DEPARTMENT MEMORANDUM

DATE: MARCH 17, 2022
TO: PLANNING AND COMMUNITY DESIGN COMMISSION
FROM: CARLOS TREJO, AICP
DIRECTOR OF PLANNING AND COMMUNITY DEVELOPMENT
RE: 545 LONG ACRES LANE
COMMUNITY DESIGN AND CONCEPT STORMWATER MANAGEMENT PLAN
REVIEW

SUBDIVISION IMPROVEMENT PLAN

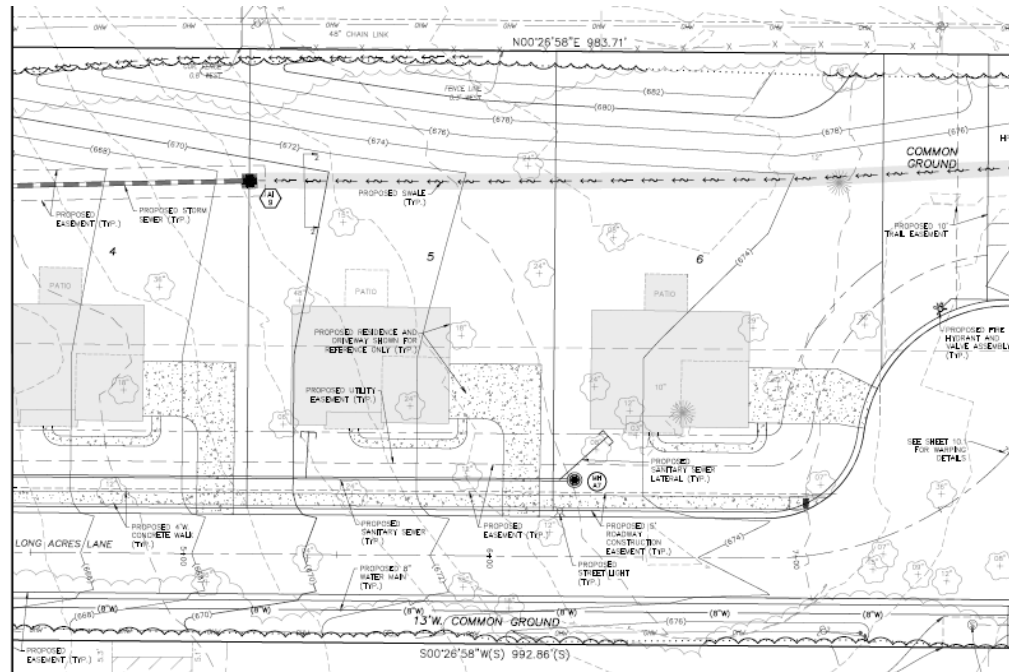
The Site Plan submitted illustrates the 10-foot easement, the subdivision indentures include language regarding the easement and average home size.

- Sump pump discharge. The location of the sump pump is at the northeast corner of the home behind the garage. The location of the sump pump discharge is not illustrated. Given the location of the sump pump on the west side of the garage driveway turnaround, staff recommends the point of discharge should be directed west and not perpendicular to the adjacent property at 553 Long Acres.

1. Top of foundation is limited to 674.7 per the approved Site Improvement Plans for the Birdie Lane Subdivision.
2. For the sump pump, the point of discharge should be directed west and not perpendicular to the adjacent property at 553 Long Acres.
